Development Services Staff Report

File Number	PL2026-078
File Name	PRELIMINARY DEVELOPMENT PLAN – Blackwell Convenience Store
Applicant	KDP Hospitality, LLC, applicant
Property Address	2661 SE Blue Pkwy
Planning Commission Date	July 9, 2026
Heard by	Planning Commission and City Council
Analyst	Hector Soto, Jr., AICP, Senior Planner

Figure 3 - C-store building with proposed shed roof design.

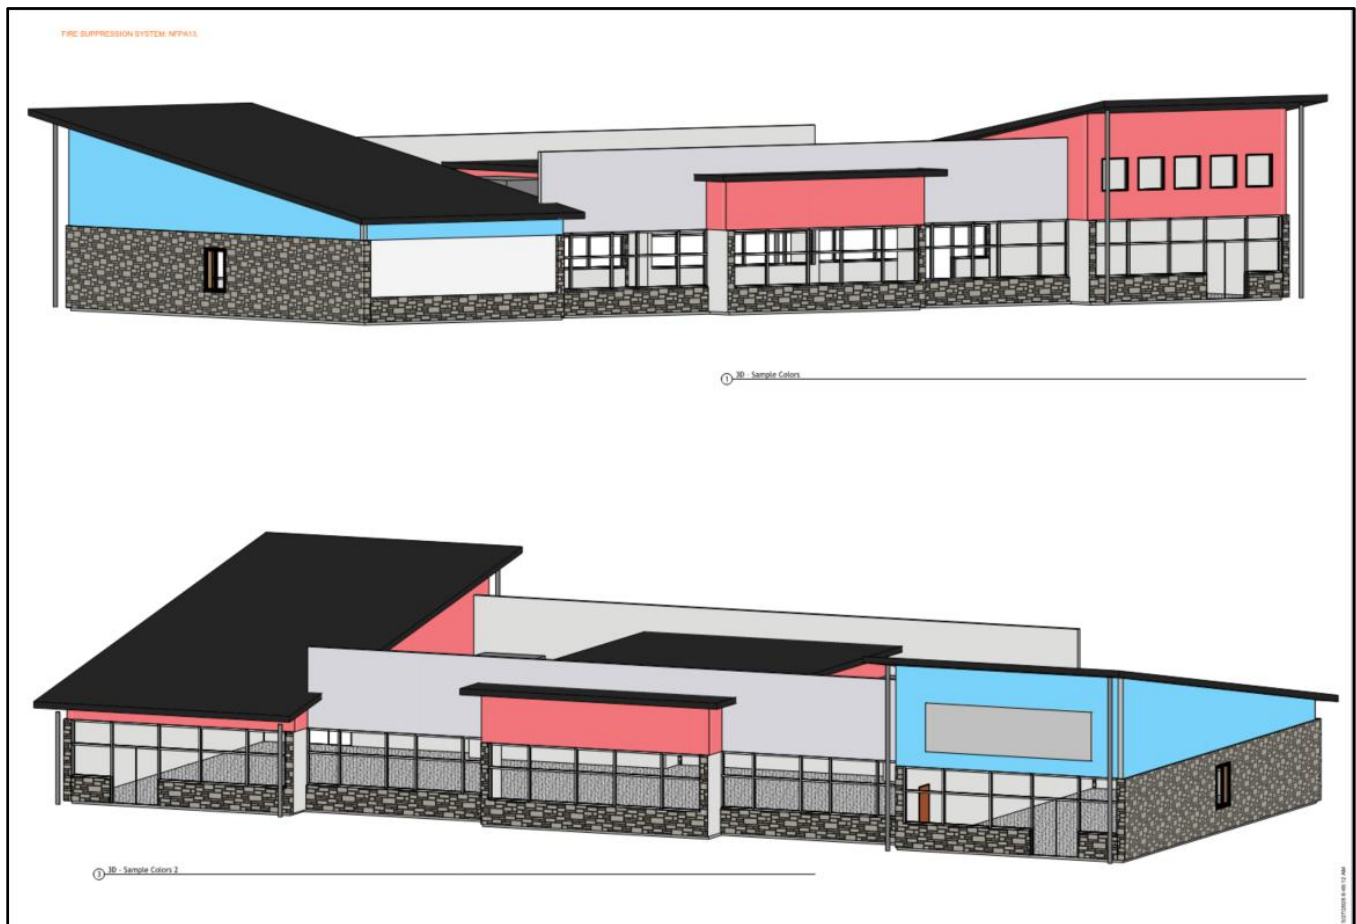
The proposed development is not expected to negatively affect the aesthetics of the subject project area or neighboring properties. The proposed building architecture and palette of materials complies with the City's architectural design standards. The applicant's proposed C-store building design is presented with two roof options for consideration. The applicant's preferred design option (Figure 3 below) uses a shed roof design on both ends of the building. The shed roofs slope opposite each other to provide the same building appearance when viewed from the north and south sides.

Both building designs and roof options comply with the City's architectural design standards. Staff equally supports the applicant's preferred and alternate roof designs. The use of both flat roofs and sloped (pitched) roofs are found on existing buildings along the US 50 Hwy corridor, though shed roofs as a subtype of a sloped roof is not found in the immediate area.

Figure 4 - C-store building with alternate stepped flat-roof design.

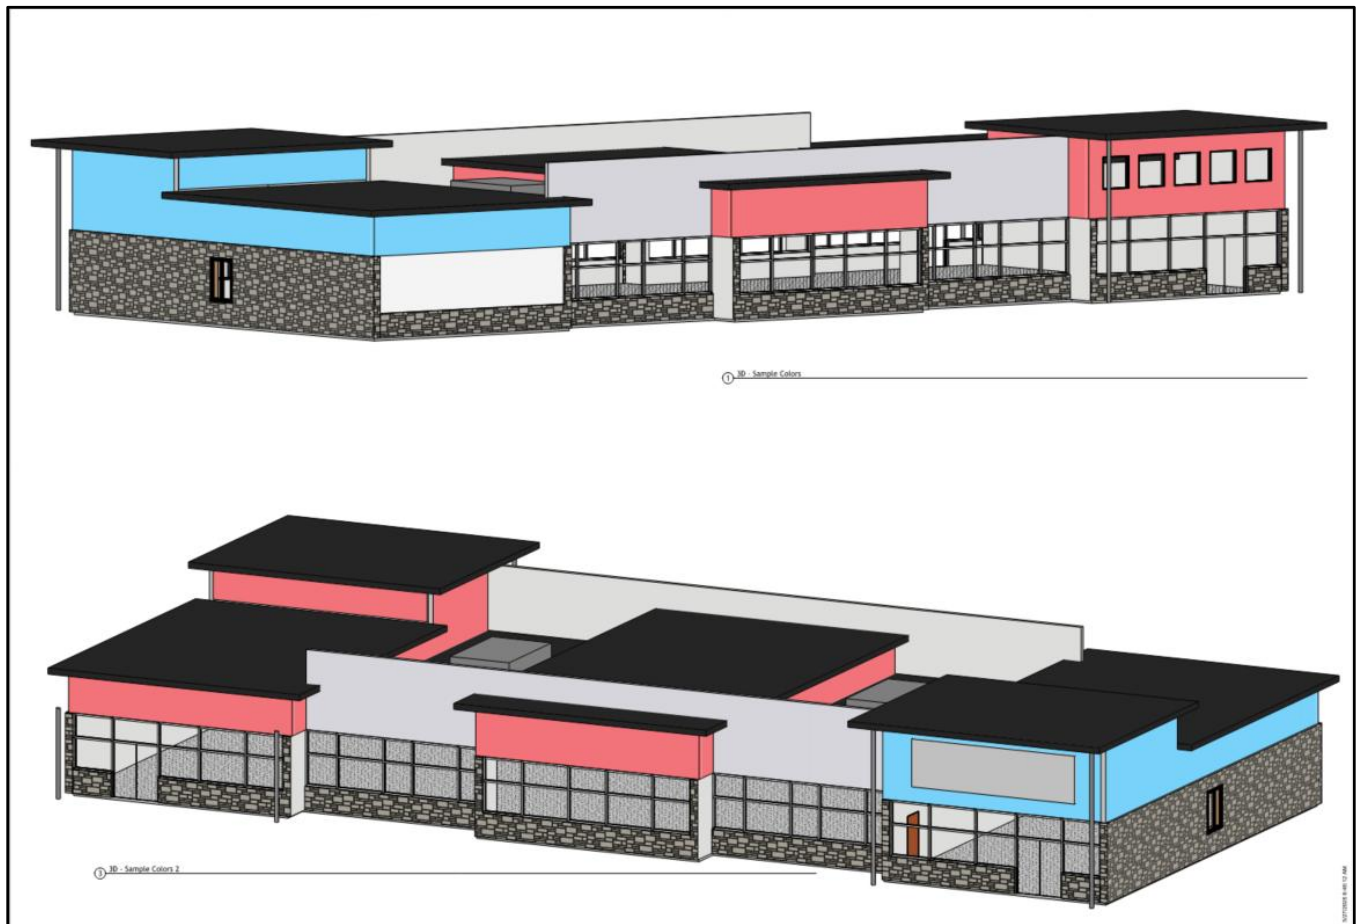
The applicant's alternate design option (Figure 4 below) uses a stepped flat-roof design on both ends of the building. Like the shed roof option, the stepped flat-roof option steps up and down opposite each other to provide the same building appearance when viewed from the north and south sides.

Figure 6 - East facade of C-store building

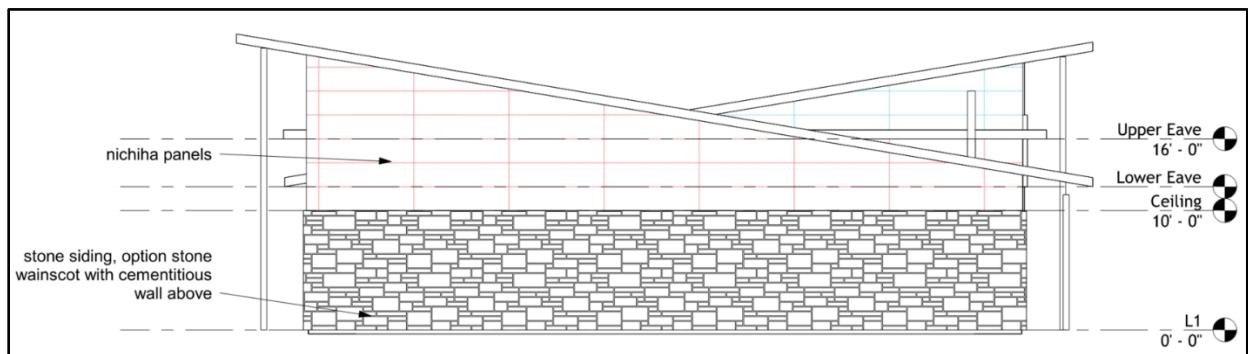
Fenestration (UDO Section 8.050.B.4.i). The applicant requests a modification. Staff supports the request.

- Required – All commercial and retail building façades that face a public or private street shall provide fenestrations with clear glass occupying no less than 50 percent (50%) of the pedestrian view zone. (The pedestrian view zone is defined as the 8'-tall of the building façade that is between 2' and 10' above the adjacent sidewalk or ground level.)
- Proposed – 0% of the pedestrian view zone along the east façade of the C-store building facing SE Blackwell is occupied by clear glass in the form of a drive-through window.

Recommended – The intent of the fenestration requirement along a building's street-facing façade is to help provide pedestrian scale to commercial buildings, provide visual interest and break up the large wall planes when viewed from the street and when experienced by pedestrians along adjacent sidewalks. The proposed building's east façade faces SE Blackwell Rd which sits between 11' and 13' below finished grade of the C-store pad site. Additionally, the sidewalks along SE Blackwell Rd are located approximately 150' from the C-store building. Although the east building elevation has no fenestration, the east elevation has a clearly defined base, middle and top by employing the use of contrasting materials, colors, and varying roofline to provide visual interest and break up the large wall planes. Proposed landscaping along the east side of the building will also help soften the view of the building when viewed from SE Blackwell Rd. Staff supports the requested modification.

1. A modification shall be granted to the minimum 50% clear glass fenestration requirement for the pedestrian view zone along the street-facing facade of a building, to allow 0% clear glass fenestration for the pedestrian view zone along the east building façade facing SE Blackwell Rd.
2. Development shall be in accordance with the preliminary development plan uploaded June 9, 2026; and architectural renderings and elevations depicting shed roof design uploaded June 9, 2026.
3. Development of Lot 1, Lot 2, and Lot 3 concept commercial and office buildings shall require separate preliminary development plan approval under a future application.
4. Development shall be in accordance with the recommended road improvements included in the TIA dated June 30, 2026, prepared by Erin Ralovo, P.E., Senior Staff Engineer.
